Access Compliance Report

Public Rights-of-Way

(Curb Ramps)

Intersection ID: 3221	Main Street: FAIRBOURNE_CT	Cross Street: HIGHCROFT_LN	Location:	NE
ADA ID: 4FA347089E4D	Ramp Type: Perp	Initial Pass/Fail: Fail	Overall Compliance: No	Severity Score: 10
Codes/Mitigation Info/Possible Solution		Field Measurements/Component Compliance

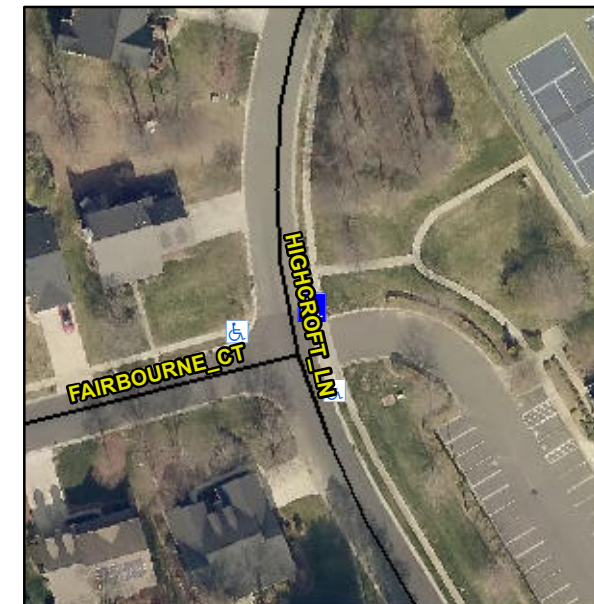
Not Found, R304.5.1

Compliance	Description	Data	Compliance	Description	Data
N/A	Ramp Length (in)	48.0	Yes	Ramp Slope (%)	6.9
No	Ramp Width (in)	41.0	Yes	Ramp XSlope (%)	2.4
N/A	Flare Type LT	N/A	N/A	Flare Type RT	N/A
N/A	Flare Slope LT (%)	N/A	N/A	Flare Slope RT (%)	N/A
N/A	Flare Traversable LT?	N/A	N/A	Flare Traversable RT?	N/A
N/A	Landing Length (in)	N/A	N/A	DWS Provided?	N/A
N/A	Landing Width (in)	N/A	N/A	DWS Contrast?	N/A
N/A	Landing Slope (%)	N/A	N/A	DWS Length (in)	N/A
N/A	Landing X Slope (%)	N/A	N/A	DWS Full Width?	N/A
N/A	Landing Curb? (Y/N)	N/A	N/A	DWS Offset (in)	N/A
N/A	Shared Landing?	N/A			
N/A	Gutter Ponding?	N/A	N/A	Gutter Slope (%)	N/A
N/A	Gutter Lip Ht (in)	N/A	N/A	Gutter X Slope (%)	N/A
N/A	Painted X Walk1?	No	N/A	Painted X Walk2?	N/A
	X Walk 1 Direction	To W		X Walk 2 Direction	N/A
N/A	X Walk 1 Width (in)	N/A	N/A	X Walk 2 Width (in)	N/A
	X Walk 1 Slope (%)	2.9		X Walk 2 Slope (%)	N/A
	X Walk 1 X Slope (%)	3.9		X Walk 2 X Slope (%)	N/A

Remove & Replace Entire Ramp.
